FIGURE 22: View loss after PPR Proposal.

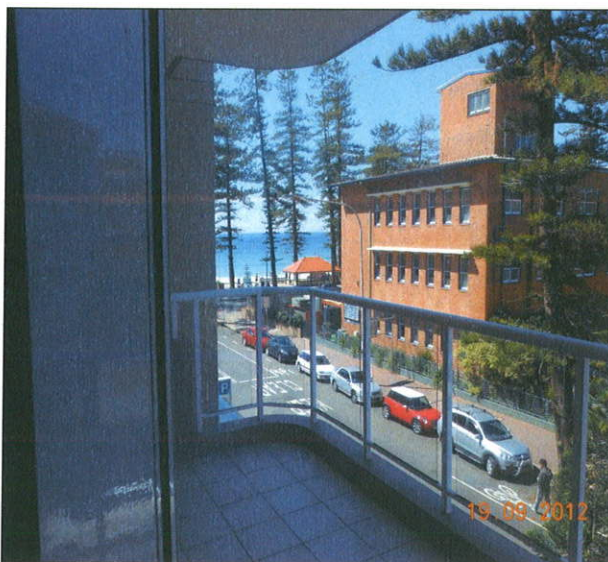
Figures 21, 23 and 25 illustrate the current views available to the inspected premises whilst the modified photographs at **Figures 22, 24, 26 and 27** illustrate the approximate view loss attributable to the EA design (green and red combined) and the PPR design (red). These figures clearly illustrate that the view loss outcome will range from minor to severe depending upon the different apartment layouts and level positions, particularly as these views are unimpeded where they are across the existing basketball court area.

Apartments shown in **Figures 22, 24 & 27** will be impacted by the proposed building. However, due to their positioning within the existing apartment complex, at mid-level or rooftop levels, this view loss is unlikely to be significantly improved by any form of complying development occurring on the subject land as the bulk of the built form would be in a similar location. The orientation of these apartments towards the beach/water relies on the existing Wentworth Street view corridor which would be reduced by any form of reasonable development on the land that complies with the Guidelines.

FIGURE 26: View Loss after PPR Proposal.

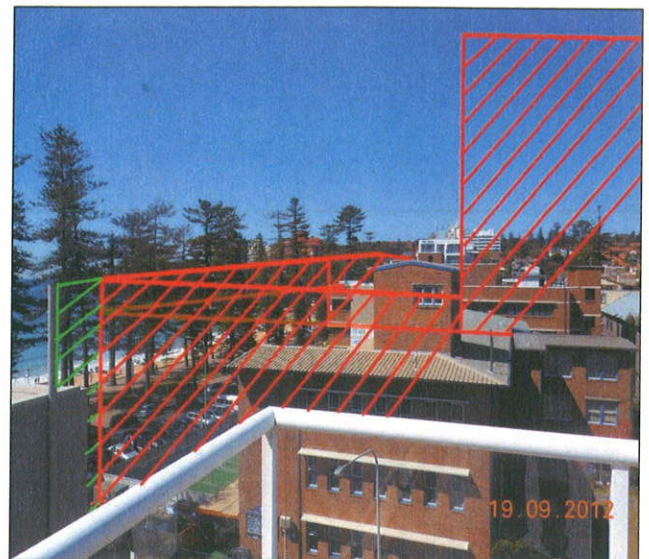
It is noted that some apartments, such as the one illustrated in **Figures 25 and 26** are positioned or orientated in such a manner that they will be adversely impacted regardless of the development that occurs in the South Steyne portion of the site. The illustrated apartment will lose the existing beachfront views but retain water and distant foreshore views. The only alternative would be to prohibit any form of reasonable development in the eastern portion of the site in order to retain those views. This would be an unreasonable outcome as the Council's Design Guidelines for the site also recommend 4-5 storey structures in this portion of the site. The majority of apartments impacted by the proposed development will have minor to moderate view loss impacts and this is considered a reasonable outcome opposite a recognised development site.

It is acknowledged that in some instances this view loss impact may be assessed as severe where existing elevated views along the beach are lost. **Figures 25 and 26** illustrate the potential reduction in view loss from the originally submitted EA (Green and Red outline) to the PPR proposal (Red outline). However, this outcome is comparable to the view loss impact of development that would generally comply with Council's Guidelines for development of the site.

FIGURE 28: PPR facade corner pole

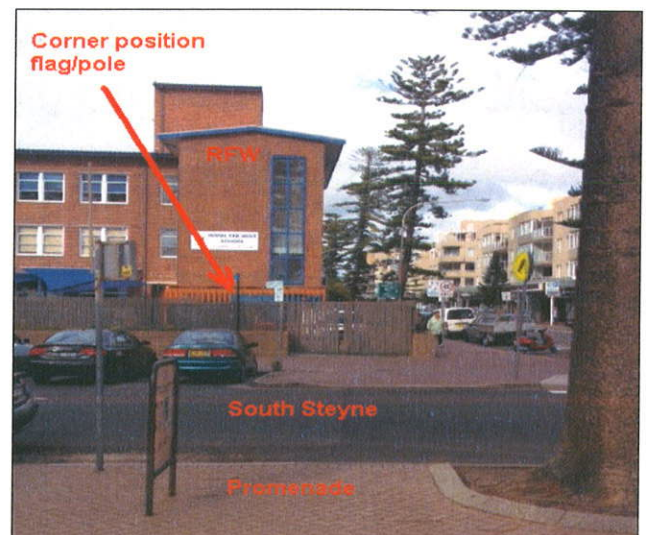
Figure 28 illustrates the location of a corner flag erected by the Proponent which identifies the proposed corner of the development at the South Steyne and Wentworth Street intersection, being six metres south of the Wentworth Street boundary alignment.

FIGURE 29: Upper Level 15m Platform in Council Guidelines

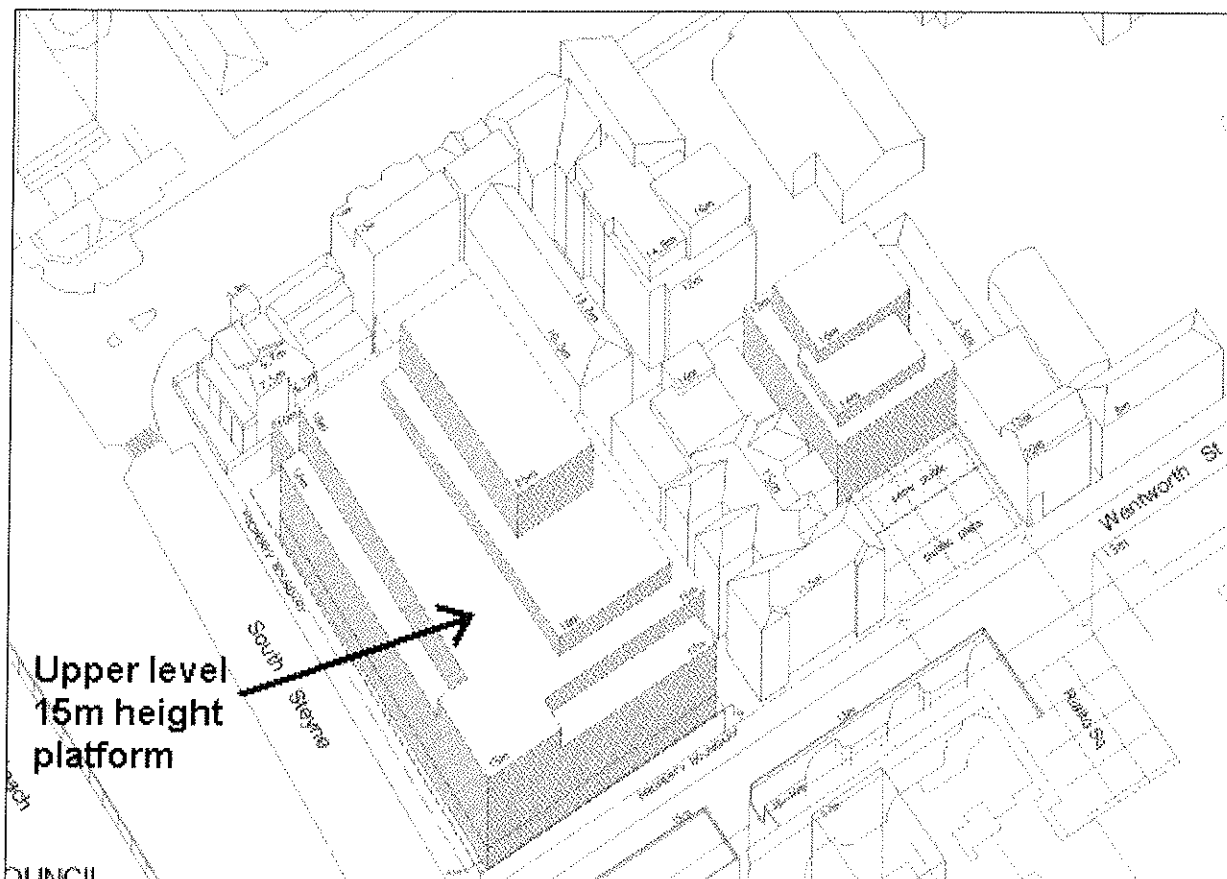
In general terms the building element at the corner of Wentworth Street and South Steyne is consistent with the overall building form proposed under Council's Guidelines which provides for a 15 metre high element on the corner that joins with an upper level recessed floor above the 12 metre high street element, as illustrated in **Figure 29** below:

Figure 29 is extracted from Manly Council's Guidelines for development of the Royal Far West site. It illustrates that although the presentation to the street will be a wall height of 12m the primary podium level would be 15m in height when assessing view loss from elevated neighbouring apartments opposite the site.

FIGURE 30 – Model presentation to Manly Beach
SOURCE: Preferred Project Report, Urbis, August 2012

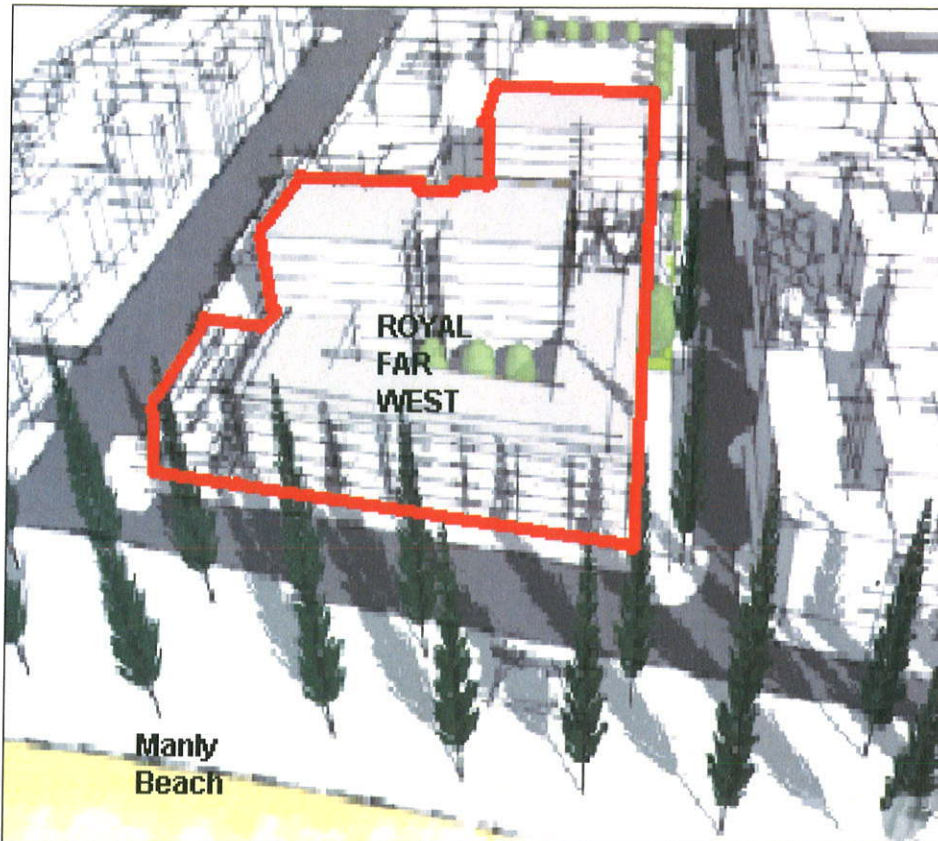
Figure 30 provides an aerial presentation of the project fronting onto South Steyne and Manly Beach. The beach front setback of the hotel tower is designed to be consistent with the existing setback provided by the "Peninsula" Apartments tower. **Figure 30** also illustrates that the tower, with the setback of 21 metres to South Steyne, will have an acceptable appearance at the promenade/beach level, subject to appropriate modification dealing with façade appearance and modulation
